PROPOSED CHANGES TO APPENDIX A
TECHNICAL SPECIFICATIONS

Attachment 1a: DRESDEN STATION UNITS 2 AND 3

Attachment 1b: QUAD CITIES STATION UNITS 1 AND 2

Attachment 1c: LASALLE COUNTY STATION UNITS 1 AND 2

FIGURE 6.1-1

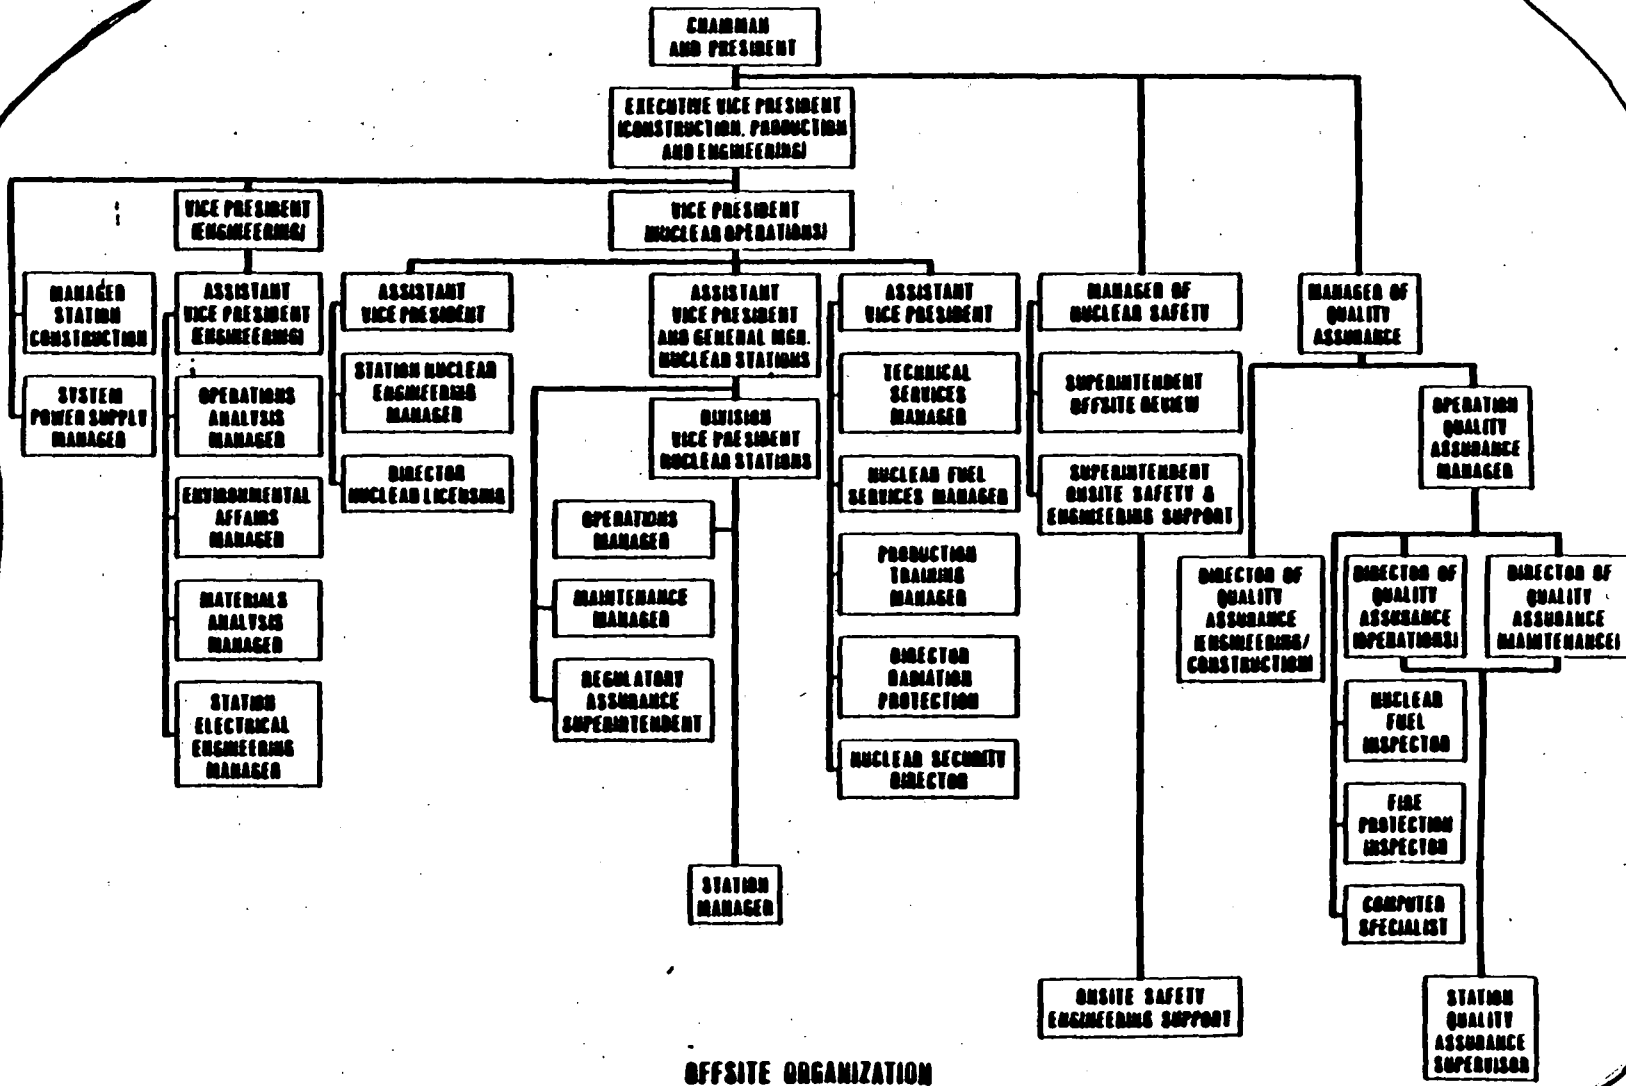
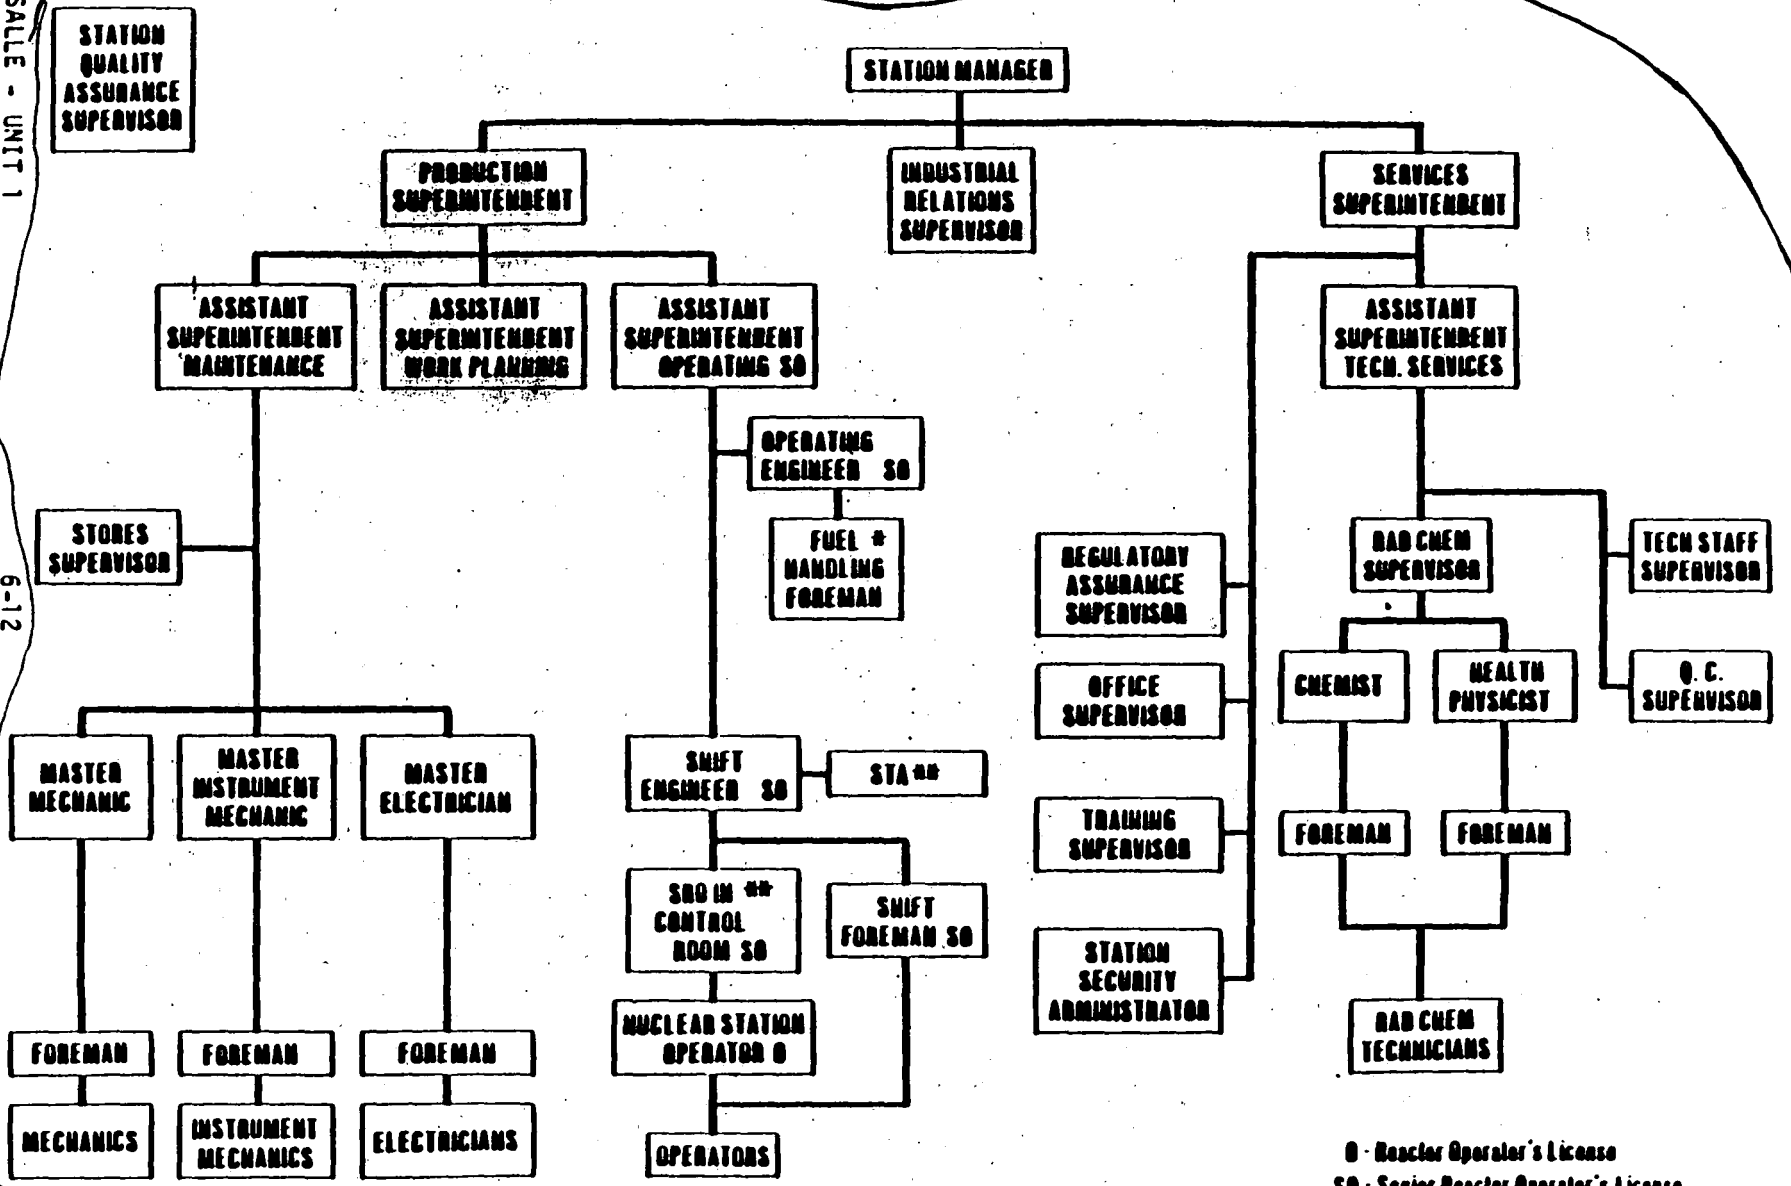
- 1) Page 6-1/ Paragraph 6.1.B -
 - a) Delete this paragraph and replace with the following statement, "The corporate management organization which relates to the operation of LaSalle Station ... of the Commonwealth Edison Company Topical Report CE-1-A."
- 2) Page 6-1/ Paragraph 6.1.c -
 - a) Delete first sentence "The normal functional organization ... shown in figure 6.1-2."
- 3) Page 6-11/ Figure 6.1-1 -
 - a) Figure 6.1-1 has been deleted.
- 4) Page 6-12/ Figure 6.1-2 -
 - a) Figure 6.1-2 has been deleted.

- a) The proposed change removes the organization charts since the appropriate charts are already contained in the Commonwealth Edison Company Corporate Topical Report CE-1-A.
